**DART SERVICE INSTRUCTION**  
**TO AMEND INSTALLATION INSTRUCTIONS D350-607-1 REV. A AND**  
**INSTRUCTIONS FOR CONTINUED AIRWORTHINESS ICA-D350-607 REV. 6**  
**REF CANADIAN STC: SH94-14**  
**REF FAA STC: SR00213NY**  
**REF EASA STC: 10016996**

A	NEW ISSUE	MB	14.09.25
REV.	DESCRIPTION	BY	DATE
DESIGN		<b>DART AEROSPACE LTD</b> HAWKESBURY, ONTARIO, CANADA	
DRAWN		DRAWING NO.	REV. A
CHECKED		DSI 9709	SHEET 1 OF 4
MFG. APPR.	N/A	TITLE	SCALE
APPROVED		PARTS LIST CORRECTION	NTS
DE APPR.		COPYRIGHT © 2014 BY DART AEROSPACE LTD <small>THIS DOCUMENT IS PRIVATE AND CONFIDENTIAL AND IS SUPPLIED ON THE EXPRESS CONDITION THAT IT IS NOT TO BE USED FOR ANY PURPOSE OR COPIED OR COMMUNICATED TO ANY OTHER PERSON WITHOUT WRITTEN PERMISSION FROM DART AEROSPACE LTD.</small>	
DATE	14.09.25

**FIGURE 1: CHANGES TO FIGURE 2 OF D350-607-1 REV. A  
AND FIGURE 25-1 OF ICA-D350-607 REV. 6**

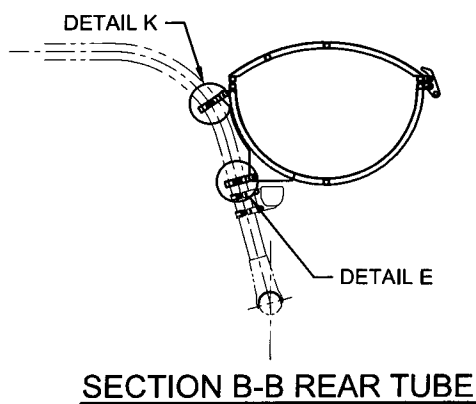
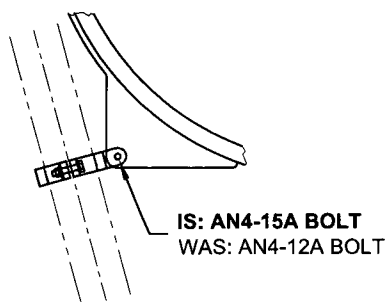
IS: AN4-15A BOLT  
WAS: AN4-12A BOLT

NO CHANGE

**FIGURE 2: CHANGES TO FIGURE 3 OF D350-607-1 REV. A  
AND FIGURE 25-2 OF ICA-D350-607 REV. 6**

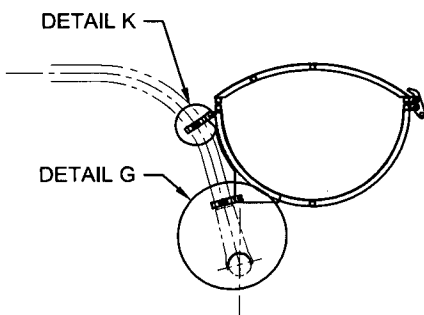
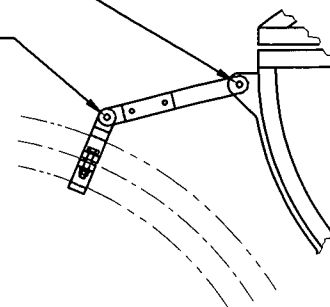
IS: AN4-15A BOLT  
WAS: AN4-12A BOLT

NO CHANGE

IS: AN4-15A BOLT  
WAS: AN4-12A BOLT

IS: AN4-15A BOLT  
WAS: AN4-12A BOLT
